RE: RESPONSE TO FURTHER ADVICE FOR PROPOSED MATERIAL CHANGE OF USE FOR A MULTIPLE DWELLING UPON LAND LOCATED AT 12 RYLATT STREET, INDOOROOPIILLY QLD 4068 - COUNCIL REFERENCE: A006915607.

Enc. *Response to Information Request*

Figure 1: Section of proposed building to demonstrate reduced floor-to-floor heights and ultimately reduce the overall peak building height.

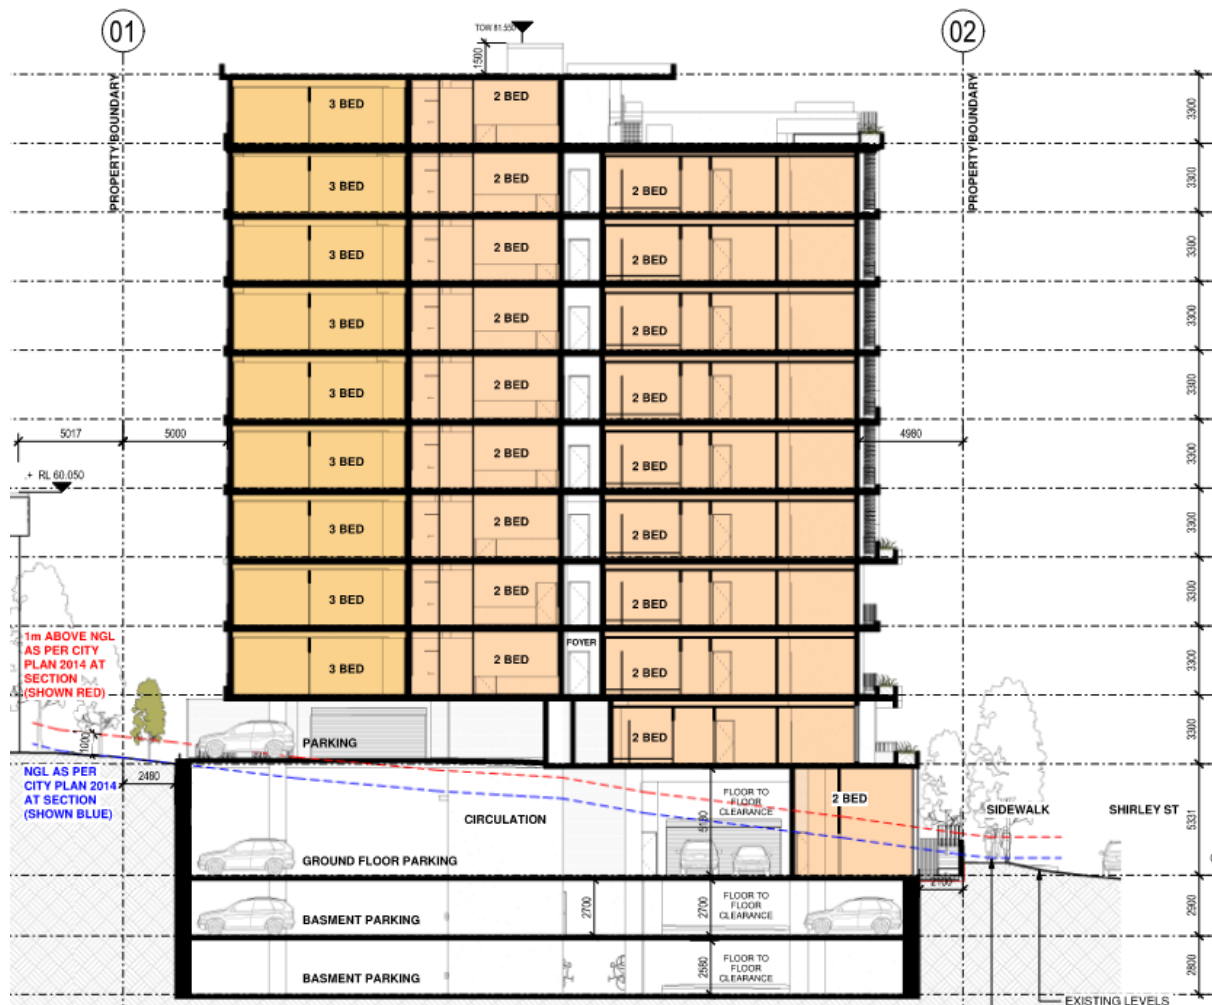
- 1) Council has reviewed the amended architectural plans submitted with the Information Request response and does not support the proposed increase in floor-to-floor heights from 3.3 m to 3.8 m. The resulting height increase creates an unacceptable amenity impact, scale and intensity that is inconsistent with Performance Outcome PO1 of the Indooroopilly Centre Neighbourhood Plan Code and Performance Outcome PO2 of the Multiple Dwelling Code. Amend the architectural plans to:
 - a) Revert the proposed floor-to-floor heights to the previously submitted scheme (3.3m); and
 - b) Ensure the overall building height and bulk are consistent with the plans prior to the amended Information Request response.

As requested by Council, the proposed architectural plans have been revised to revert the proposed floor-to-floor heights consistent with the previously submitted scheme (i.e. 3.3m), ultimately reducing the overall peak building height. As per the Amended Architectural Plans prepared by Z Architects enclosed, the peak building height (i.e. top of lift core) will not exceed RL 81.55m AHD, matching the previous scheme originally submitted with Council.
